Re: Many Rocks Pressure
Maintenance Project No. 2
San Juan County, New Mexico

In accordance with Rule 11 of the findings of Case No. 2948, Order No. R-2622, concerning the Many Rocks-Gallup Pressure Maintenance Project No. 2 in San Juan County, New Mexico, The Atlantic Refining Company requests approval to convert the following two wells to injection:

I have reviewed the application of Atlantic Refining Company which seeks to make changes in their waterflood plan in the Many Rocks Pressure Maintenance Project No. 2 in San Juan County.

SCHEMATIC DRAWING WELL NO. 12

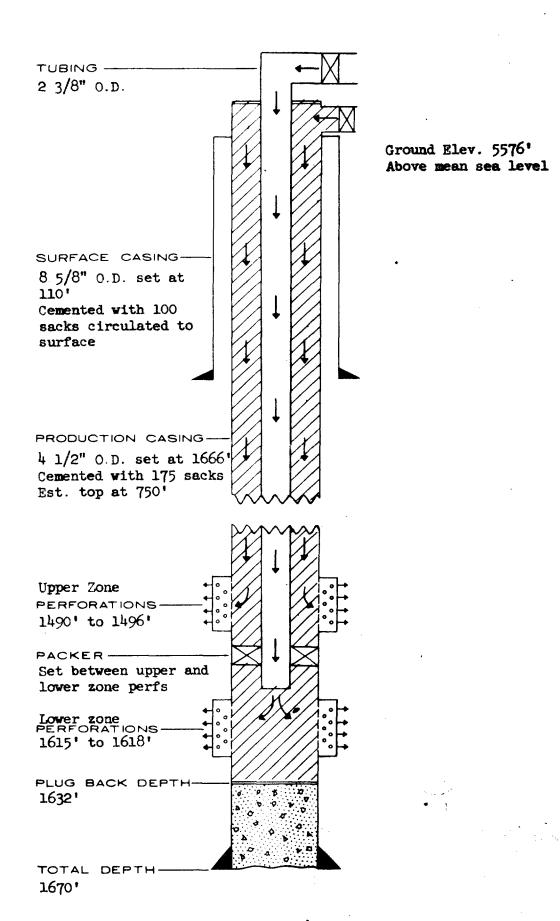
Reference is made to your application to the New Mexico Oil Conservation Commission which socks to make changes in your water flood plan in the Many Rocks Pressure Maintenance Project No. 2 in San Juan County, New Mexico. The information set forth in your application is not sufficient for me to determine what the position of the State Engineer should be. I would appreciate receiving the following information:

- 1. On what date was the 4% inch production casing set in each of the subject walls?
- 2. Was the casing new when installed in each case?
- 3. In the event that a casing loak occurs, how can injection water be prevented from entering permeable formations between depths 100 feet and 750 feet in Well No. 12, and between depths 90 feet and 1160 feet in well No. 16?
- 4. What will the maximum injection pressure be on the fluid being injected down the annulus between the 4½ inch casing and the 2 3/8 inch tubing in each case?
- 5. What is the anticipated life of the project?

- 1) On what date was the $4\frac{1}{2}$ inch production casing set in each of the \cdot subject wells? - Well No. 12, September 27, 1963, Well No. 16, February 6, 1963.

- 2) Was the casing new when installed in each case? Well No. 12 casing was new when run. Well No. 16 casing consisted of 35 joints of 9.5# per ft. new casing and 20 joints of 11.6# per ft. casing which was run once in a dry hole. The 11.6# casing was in excellent condition when set in Well No. 16. There was no corrosion present and the original paint was still in tact. The 9.5# casing is on the top and the 11.6# casing is probably all covered with cement. It should be noted that the entire casing string was tested to 2500# for 30 minutes without detection of a leak.

- In the event that a casing leak occurs, how can injection water be prevented from entering permeable formations between depths 100 feet and 750 feet in Well No. 12, and between depths 99 feet and 1160 feet in Well No. 16? - The formations in the intervals in question are primarily shale and impermeable. If a casing leak should occur, it would be detected immediately by a leak at the bradenhead. Once a leak is detected, it would be repaired by means of cementing or in an extreme case running a liner inside the production casing. We feel that a casing leak is improbable as all injected water will be inhibited for corrosion. The inhibition program is now in effect for the other wells in this project now on injection.

- 4) What will the maximum injection pressure be on the fluid being injected down the annulus between the 4½ inch casing and the 2 3/8 inch tubing in each case? At the present time we expect the maximum injection pressure on either of the wells to be about 600 psig at the surface. This pressure may by necessity be raised to approximately 800 psig in the future.
- 5) What is the anticipated life of the project? We expect the water injection project to be in operation until approximately 1975.
